Re: Final Plat S/D 87-26 - PILAND LAKE ADDITION

PILAND LAKE ADDITION

FINAL PLAT

S/D No.: 87-26 Name: PILAND LAKE ADDITION

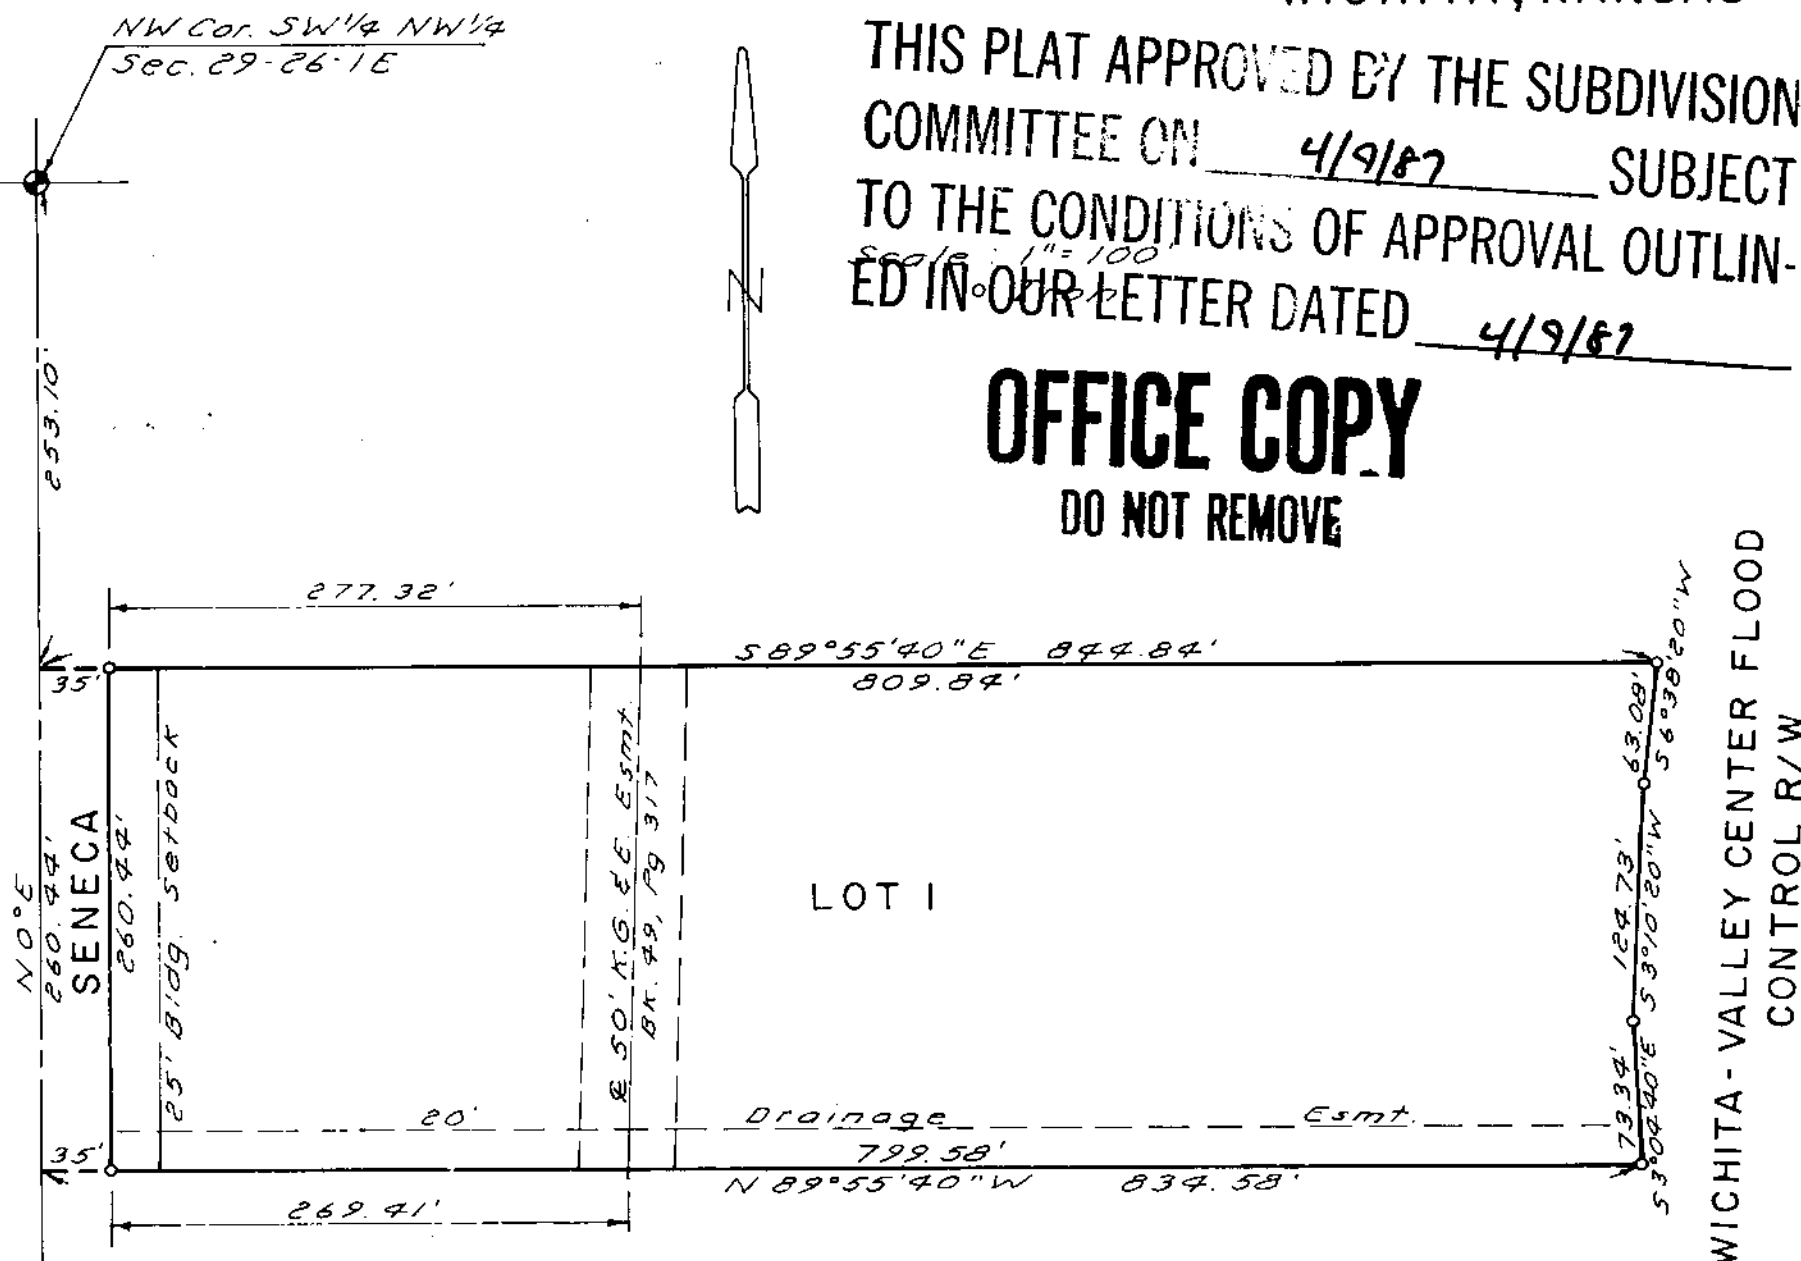
- C. The final plat shall indicate, on the face of the plat and in the plat's text, that this plat is subject to a required minimum building pad elevation of 1324 Mean Sea Level. This minimum building pad shall also be referenced in City Datum.

- A. Since neither municipal water nor sanitary sewer is available to serve this property, the applicant shall contact the Environmental Health Division of the Health Department to find out what tests may be necessary and what standards are to be met for approval of on-site sewerage facilities and water wells. A memorandum shall be obtained specifying approval.

- B. The applicant is advised that generally lots of this large size are discouraged within the urban growth area, and particularly within the City Limits, because of the potential for very large assessments for sewer, water and street pavement.

- C. The applicant's engineer is advised that the Register of Deeds is requiring the name(s) of the notary public, who acknowledges the signatures on this plat, to be printed beneath the notary's signature.

- E. Perimeter closure computations shall be submitted with the final plat tracing. Section 5-101(C).
- F. Recording of the plat within 30 days after approval by the Board of City Commissioners.

- G. The representative from the City Engineer's office should be prepared to comment on the status of the applicant's drainage plan.
